### 2007 Touring Model PDI Manual and Accessory Fuse

P&A fuse location

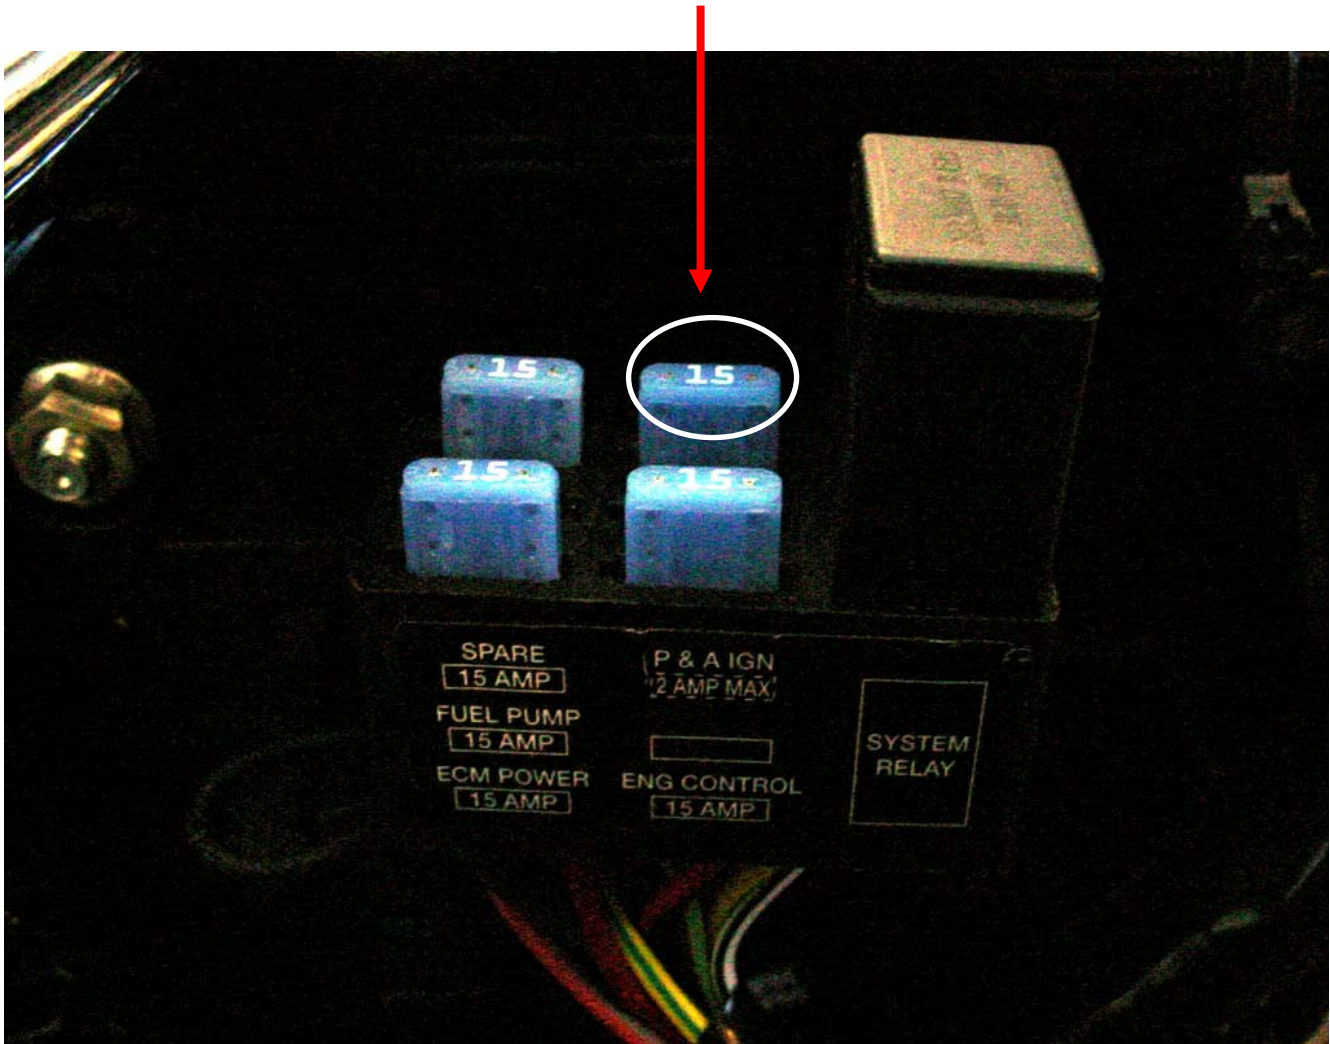
In the 2007 Touring model PDI manual on page 2-2, under "Installing Fuel Pump Fuse", it instructs you to remove the spare fuse and install it in the fuel pump fuse location. This is incorrect and should read: Remove the 15-amp fuel pump fuse located in the P&A fuse slot of the fuse-block located under the right side cover, and install it in the fuel pump fuse location. Please correct your manuals to reflect this change.

The fuel pump fuse is located in the P&A slot when you receive the motorcycle.

The accessory fuse on 2007 Touring models has been moved to the EFI fuse block, located under the right hand side cover. We are correcting I-Sheets to reflect this change as we find errors but be advised some may contain outdated information.
